**Torrington Area Health District**  
**350 Main St. - Suite A; Torrington, Ct 06790**

**T A H D Is A Equal Opportunity Provider**  
**Design Review For**  
**Subsurface Sewage Disposal System**

226	Millerton Rd	Salisbury			
Lot #	Street #	Street Name	Town	Subdivision	
Agostino Galuzzo		P. O. Box 1306		Lakeville	Ct. 06069
Owner		Owner Address		Town	State Zip

Plan Date: January 21, 2024      Plan prepared by George Johannesen

PROPOSED SANITARY SEWAGE DISPOSAL  
SYSTEM DESIGN PLAN

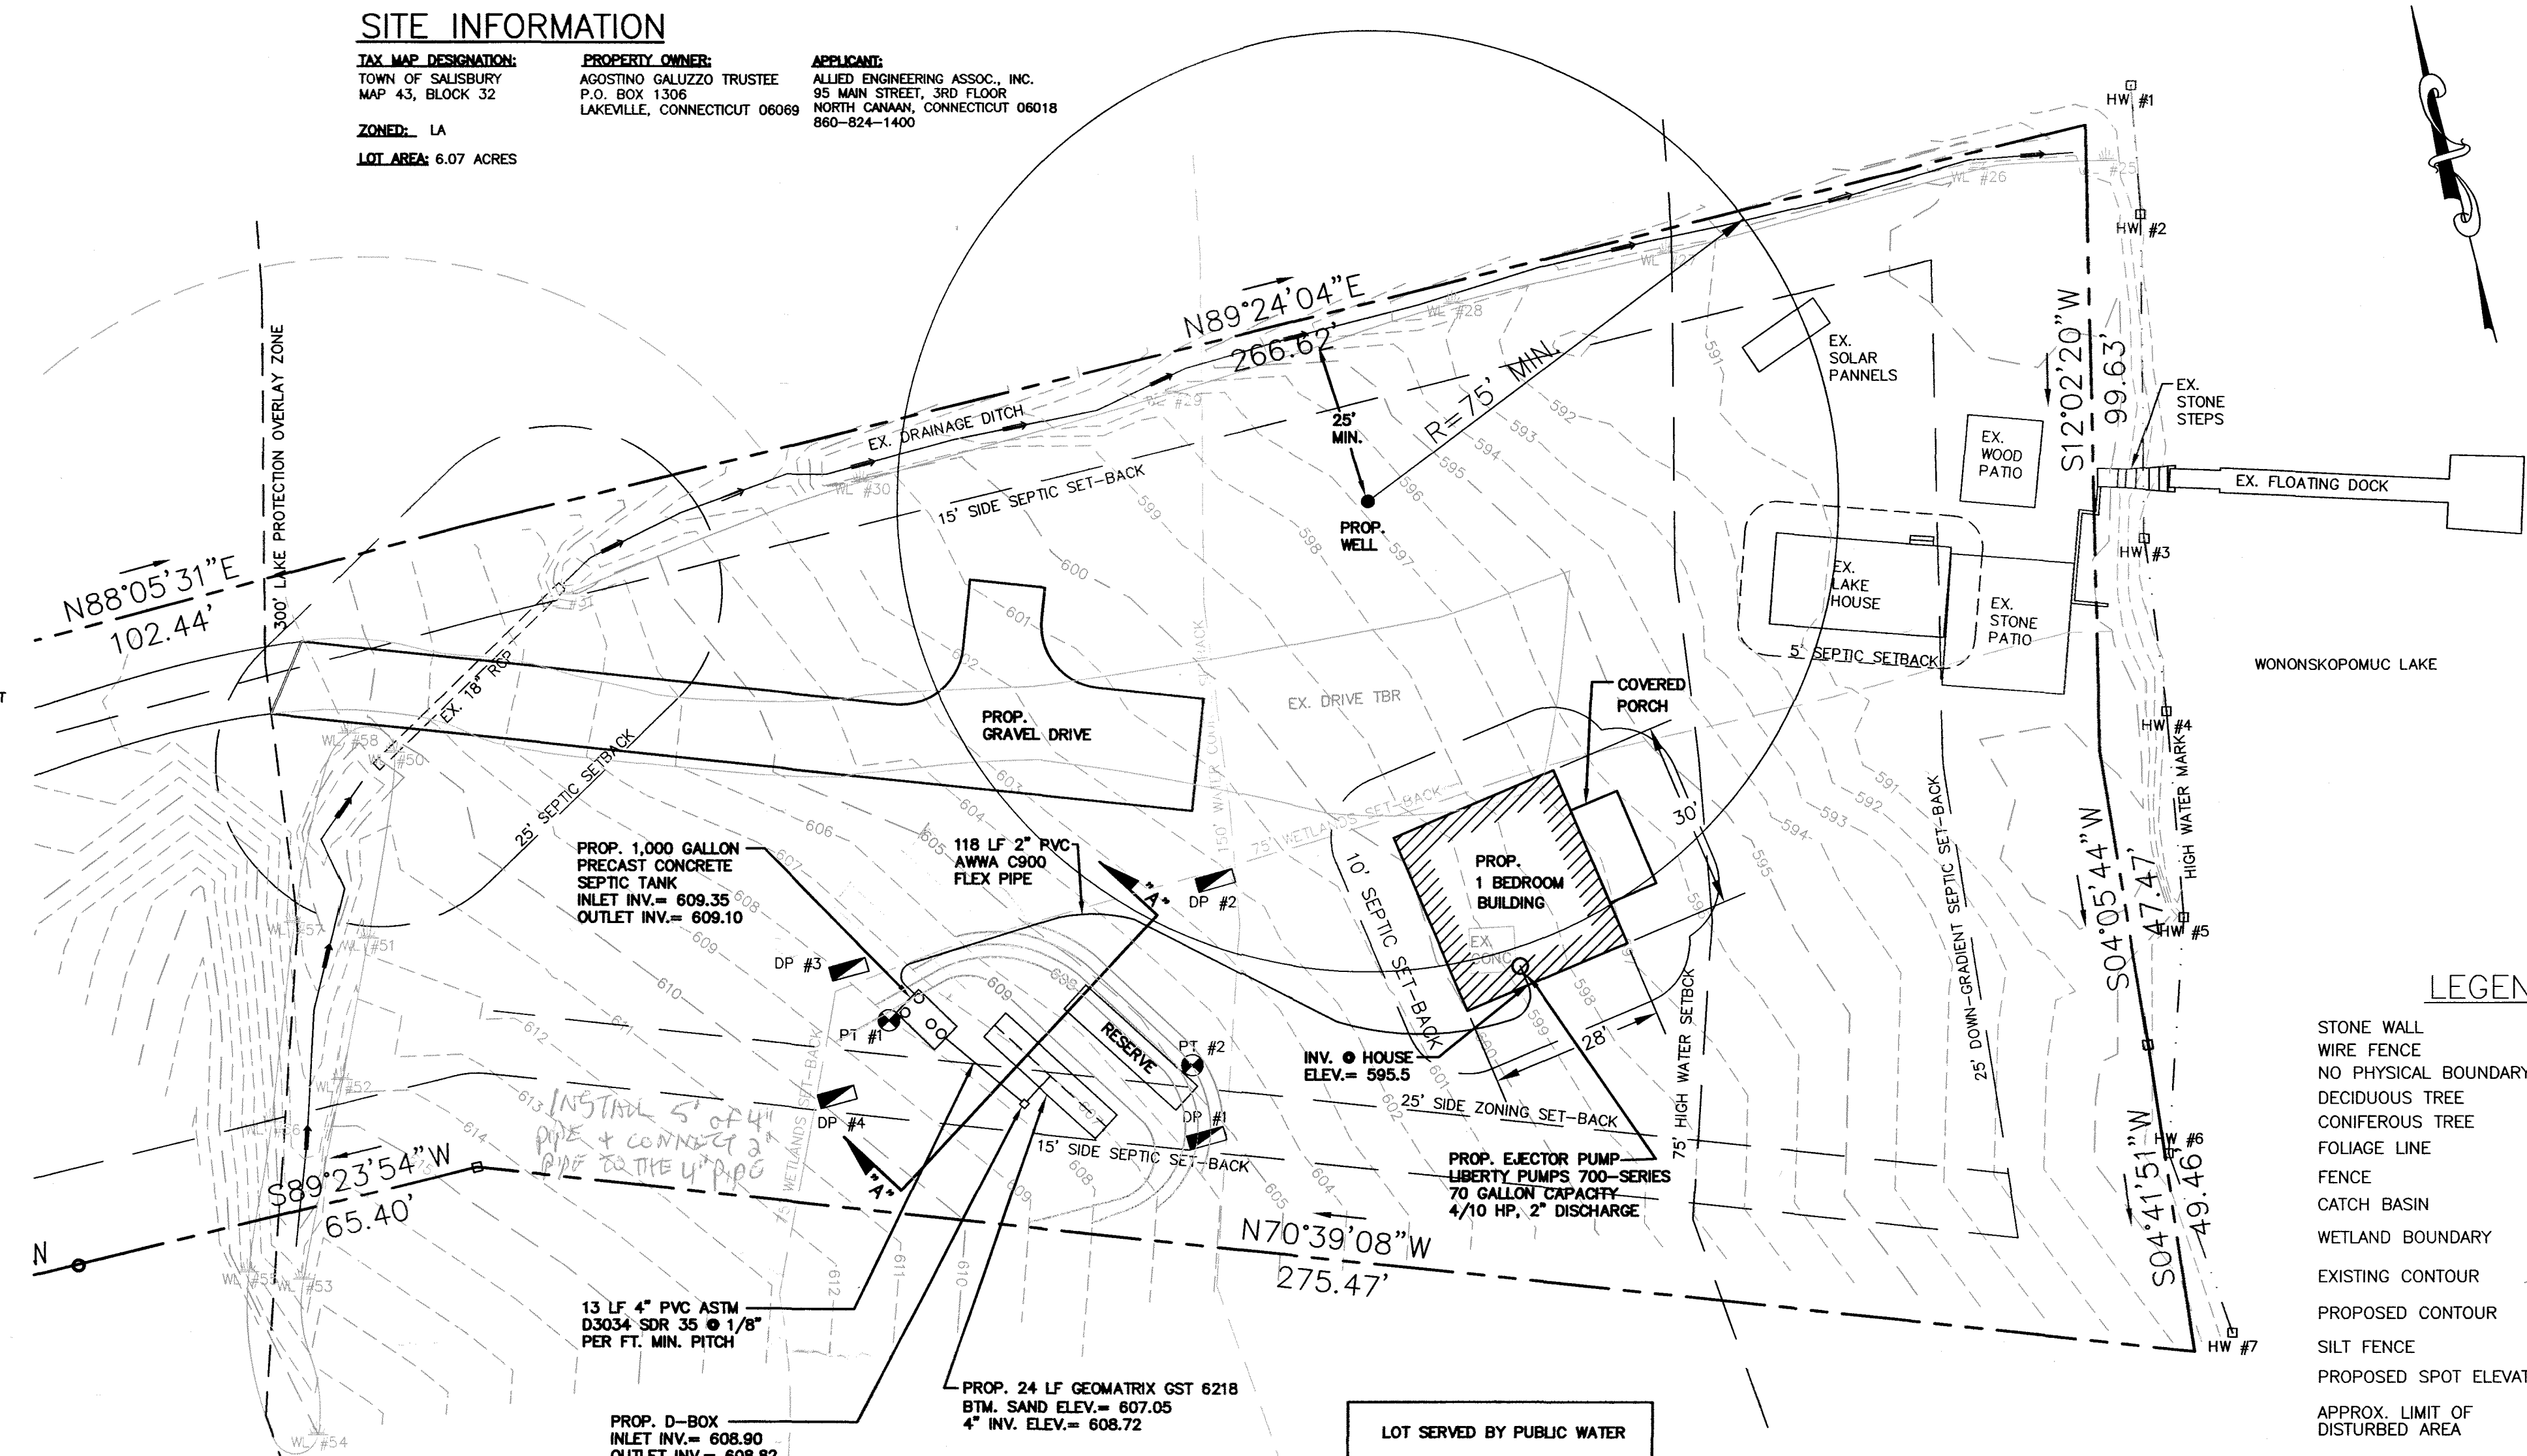
(2) Perk Tests In Fill By Engineer

- 1) Building, well, and septic system to be field staked by the design engineer or surveyor.
- 2) Force main should discharge to the septic tank via a 4" pipe connection before entering the tank.
- 3) System to be installed when soil moisture is low.
- 4) Sewage pump to be 75' from the well, as shown, UNLESS in a monolithic chamber.
- 5) An exception to drill a well within 200' of a public water supply has been approved by the State Dept of Health.
